Docket Number EPA-HQ-OAR-2011-0081  
Response to Petition From New Jersey Regarding SO<sub>2</sub>  
Emissions From the Portland Generating Station  
(76 FR 19662; April 7, 2011)

# Response to Comments Document

U.S. Environmental Protection Agency  
Office of Air and Radiation  
October 2011

Figure 4. CALPUFF Predictions of the 99th Percentile 1-Hour Sulfur Dioxide Impacts due to 2003 Allowable Emissions from the Portland Power Plant

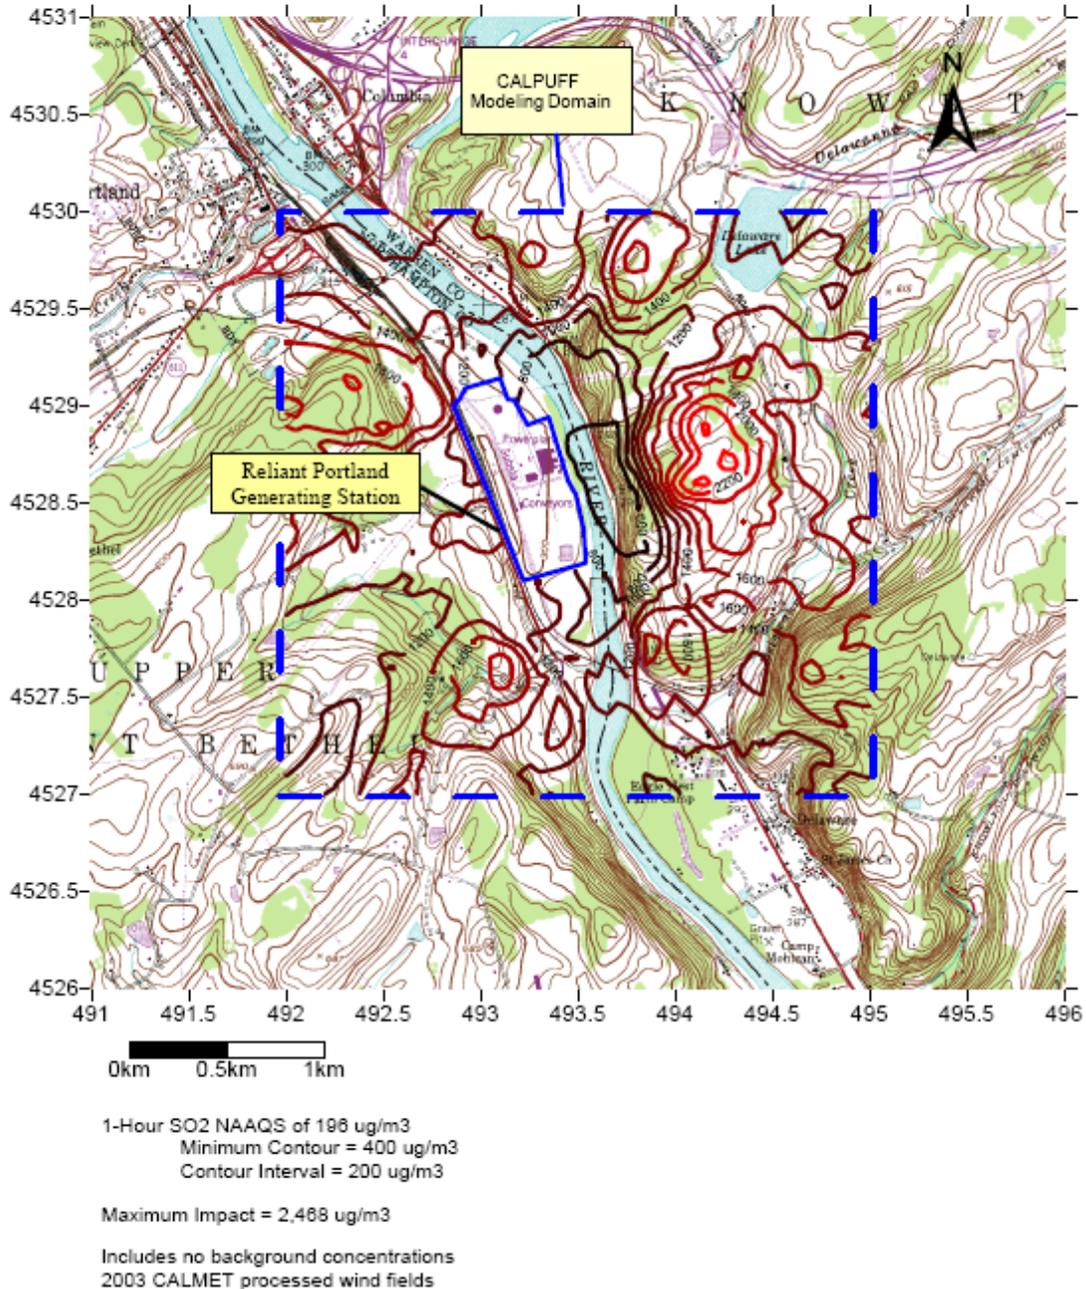
*EPA's comments incorrectly state that the results of the 2002 CALPUFF modeling analysis are unrealistic and also ignore the results of the 2003 CALPUFF modeling. The 2002 CALPUFF modeling used a coarse 12 km MM-5 grid with no nearby surface observations. EPA must also consider the submitted CALPUFF modeling that used 2003 meteorological data that was part of the NJDEP supplemental 126 Petition.*

*The 2003 CALPUFF modeling used a much more refined wind field from CALMET that utilized a 4 km MM-5 meteorological grid and the winds from two local 10 meter meteorological towers, and 10-meter DEM data. A receptor grid with 50 meter receptor spacing close in to the facility was used in CALPUFF. Figure 4 graphically depicts the spatial distribution of impacts surrounding the facility for the CALPUFF 2003 modeling run. Maximum impacts are located in elevated terrain approximately 1 km across the Delaware River in New Jersey. The spatial distribution of impacts is very similar to that predicted by EPA's AERMOD modeling."*

**Response:**

AERMOD. Figure 4 included in Appendix A of NJDEP's comments on our assessment of the CALPUFF validation study only shows contours for the 2003 CALPUFF results across a 3km-by-3km domain, but exhibits several localized peaks above 1,800  $\mu\text{g}/\text{m}^3$  within about 1 km of the plant, with concentrations exceeding 1,200  $\mu\text{g}/\text{m}^3$  within about 500 meters NW of the main stacks at elevations well below stack top, several times higher than AERMOD modeled impacts in that area. We disagree with NJDEP's assertion that "the spatial distribution of impacts [based on 2003 CALPUFF results] is very similar to that predicted by EPA's AERMOD modeling." Although we do not have any ambient  $\text{SO}_2$  monitored data in the vicinity of the peak impacts from Portland predicted by the CALPUFF model, we believe that the EPA analysis of modeled vs. monitored concentrations using the Columbia, New Jersey ambient  $\text{SO}_2$  monitor located about 2 kilometers northeast of Portland support our assessment that the CALPUFF modeling results for Portland submitted by NJDEP show ambient  $\text{SO}_2$  impacts that are unrealistically high. Based on the EPA analysis, which is similar to the analysis included in NJDEP's trajectory analysis for the Columbia monitor, the average of the predicted/observed ratios of the top 10 daily maximum 1-hour values for CALPUFF were 3.26 for the 1992-93 meteorological data and 3.87 for the 2002 meteorological data. For comparison, the average of the predicted/observed ratios of the top 10 daily maximum 1-hour values for AERMOD was 1.14. The EPA analysis used an emission scenario of 100 percent load and 70 percent of allowable emissions for Portland units 1 and 2, which is representative of peak operating conditions for Portland during the period of monitoring data and reflects the fact that the sulfur content of the fuel being burned at Portland was typically about 70 percent of the allowable sulfur content. Additional details regarding these analyses related to the Columbia monitoring data are provided in Appendix B of the EPA final rule Modeling TSD.
